**RESOLUTION TO THE SOUTH GROUNDWATER  
CONTAMINATION PLUME EE/CA COMMENTS**

**10/18/90**

**DOE-117-91  
DOE-FMPC/USEPA  
10  
LETTER  
OU5**

DISPUTE RESOLUTION FOR THE SOUTH PLUME EE/CA

FIGURE 3

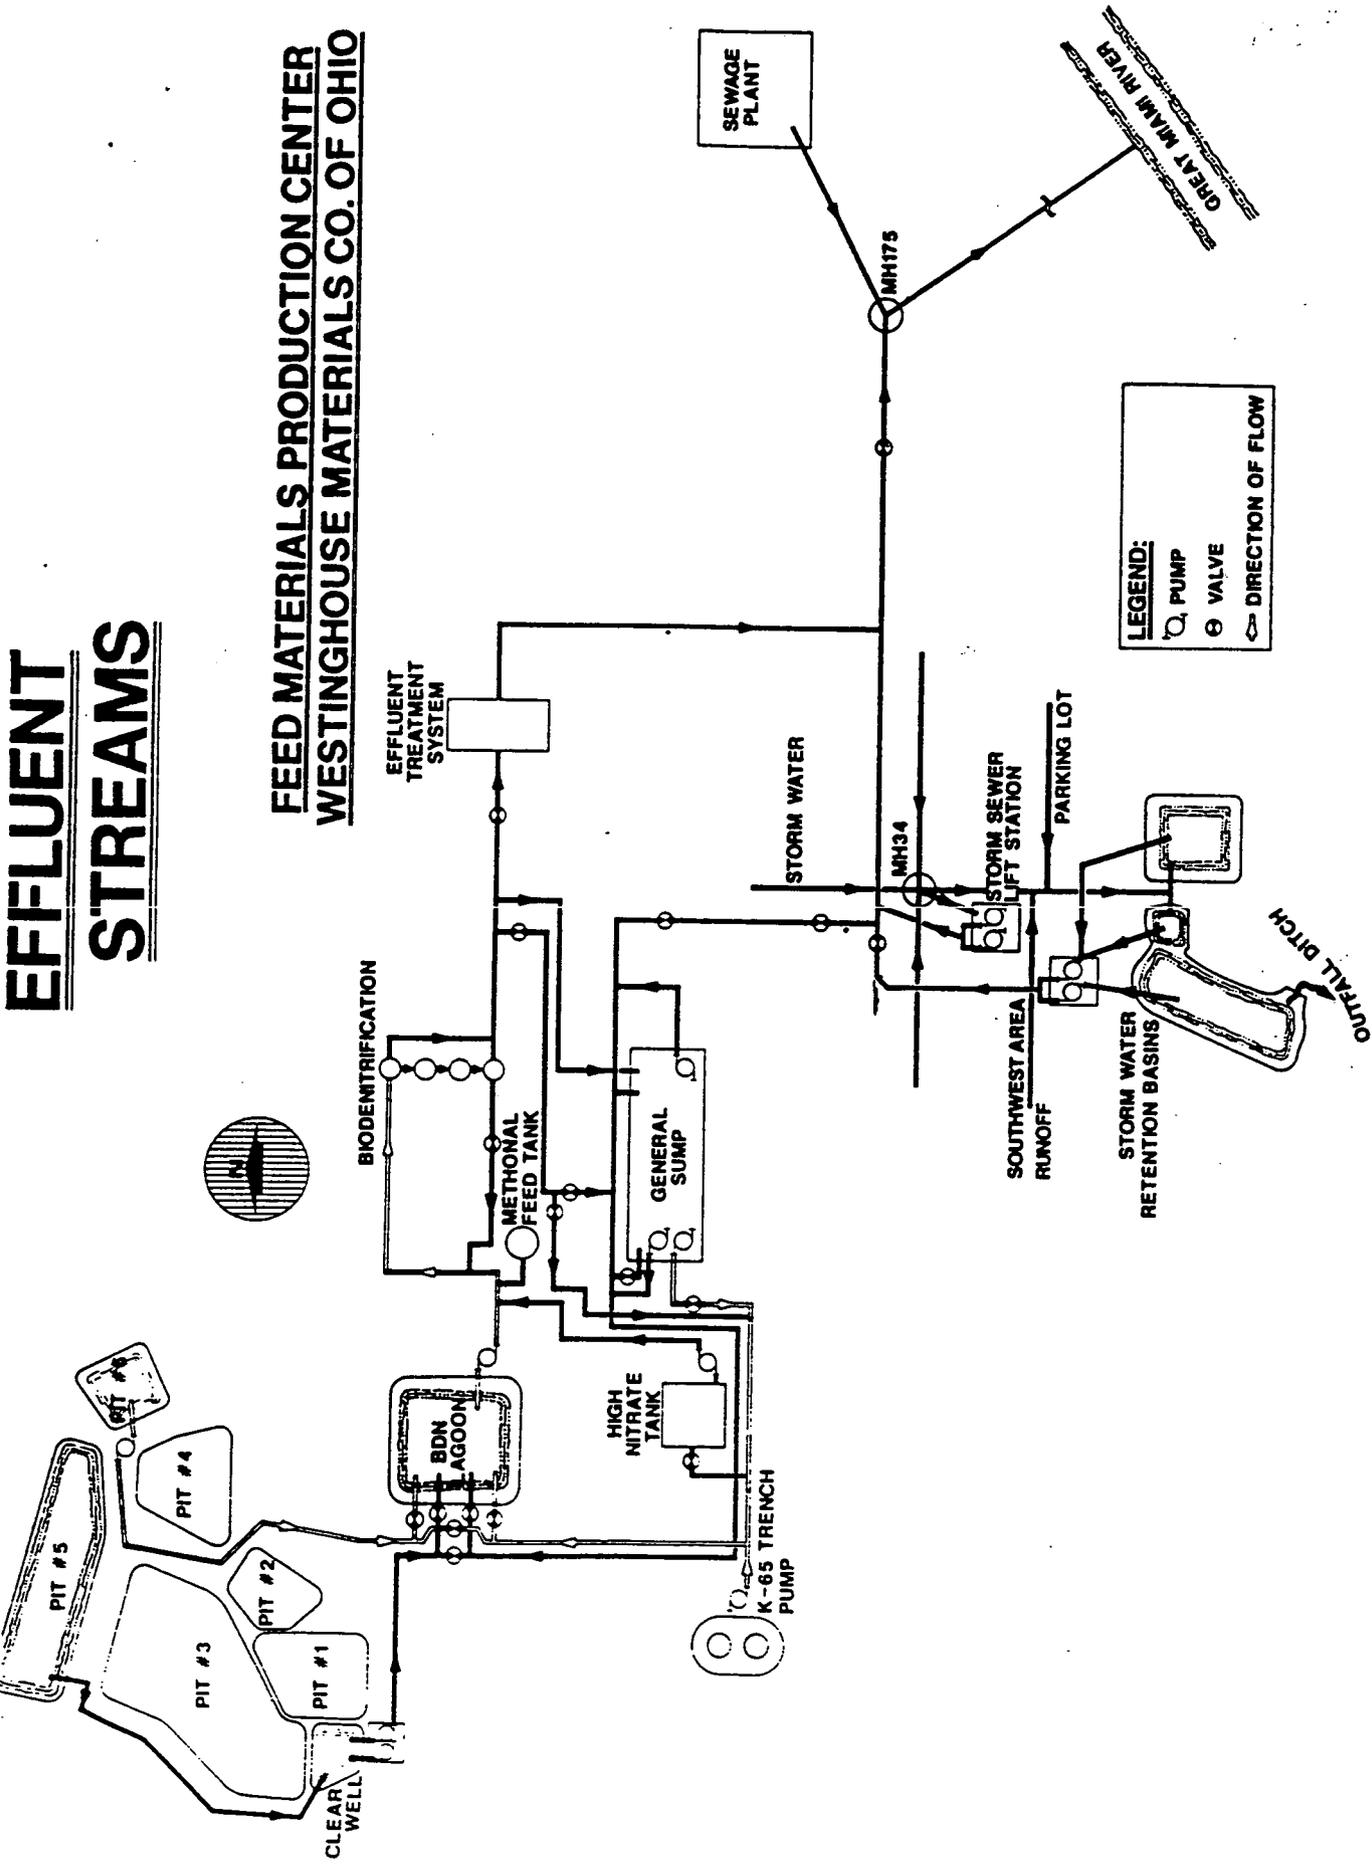
4A. Comment:

Stormwater collected from the proposed waste pit area stormwater collection system [should] be treated in the "interim" treatment system.

Obtaining the 150 GPM flow would require locating the "interim" treatment system downstream of the tie-in of the ETS discharge to the effluent force main. This is also physically located downstream of all flows except for the Sewage Treatment Plant discharge which occurs at Manhole 175 (see Figure 3). Therefore, the composition of wastewaters to the treatment system would vary depending on which batch discharges were being pumped. This could make the design of the treatment system more complex and delay the system from being on-line as soon as possible.

FIGURE 1

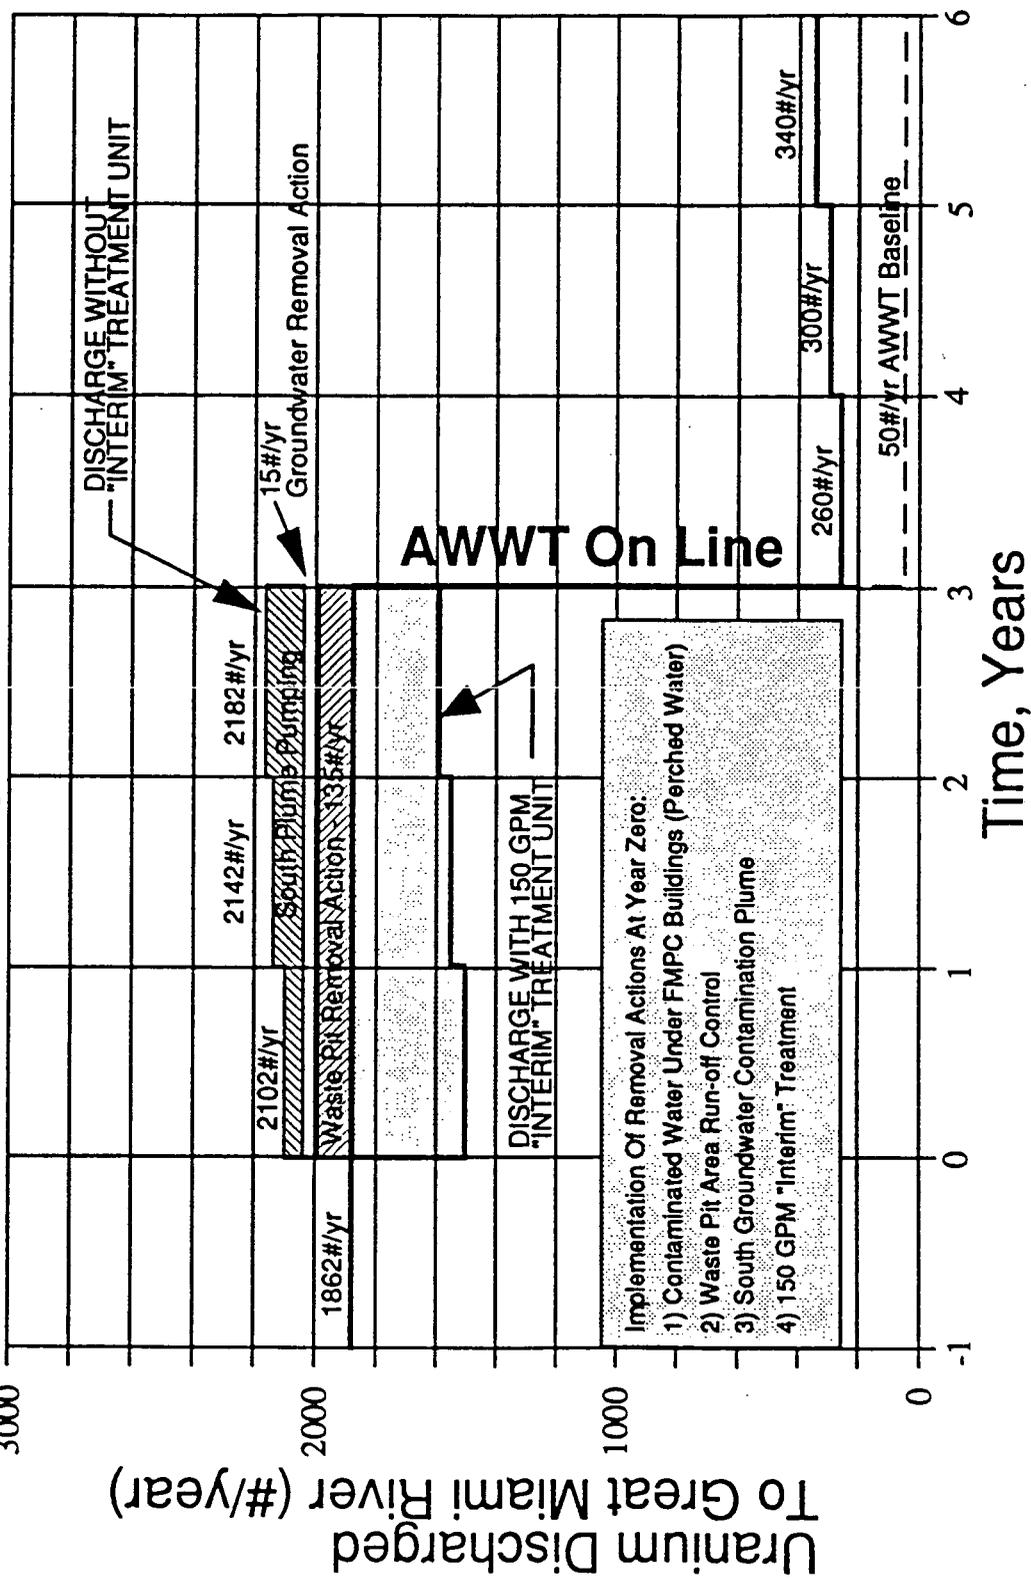
1. Comment:

Provid[e an "interim"] treatment system(s) that would treat up to 300 gallons per minute (GPM) instead of the 150 GPM [proposed].

In determining the capacity of the "interim" treatment system, 1989 discharge data was used. The 1989 uranium discharge to the Great Miami River was 1862 lbs U/yr in a flow averaging 472 GPM. This equates to approximately 3.9 lbs U/yr/GPM (1862 lbs U/yr divided by 472 GPM equals 3.9 lbs U/yr/GPM). To remove a minimum of 320 lbs U/yr from the existing FMPC wastewater treatment system discharge, the "interim" treatment system

must have an 82 GPM capacity (320 lbs U/yr divided by 3.9 lbs U/yr/GPM equals 82 GPM). To provide for a factor of safety, an "interim" treatment system with a capacity of 150 GPM and the capability of reducing uranium concentrations in treated water to 20 parts per billion (ppb) was proposed. This 150 GPM treatment capacity will ensure no additional uranium mass will be discharged. Indeed, the 150 GPM system proposed will remove over 500 lbs U/yr resulting in a net decrease to the present FMPC uranium discharge level (see Figure 1).

The overall discharge of uranium during the first year of AWWT operation would be approximately 260 lbs U/yr (170 lbs from the South Plume plus 40 lbs anticipated annual increase in mass during South Plume Removal Action plus 50 lbs unremoved during AWWT treatment), see the attached Figure 1. This initial uranium level would increase by approximately 40 lbs U/yr thereafter until treatment of the South Plume is justified and implemented by the Record of Decision (ROD) for Operable Unit #5. The AWWT Phase I will have the flexibility to treat 700 GPM of the South Plume discharges in the absence of treating contaminated stormwater runoff during periods of dry weather (estimated at approximately 50% of the time). Otherwise, the extracted water will be discharged with the treated FMPC wastewaters through the effluent line to the Great Miami River.
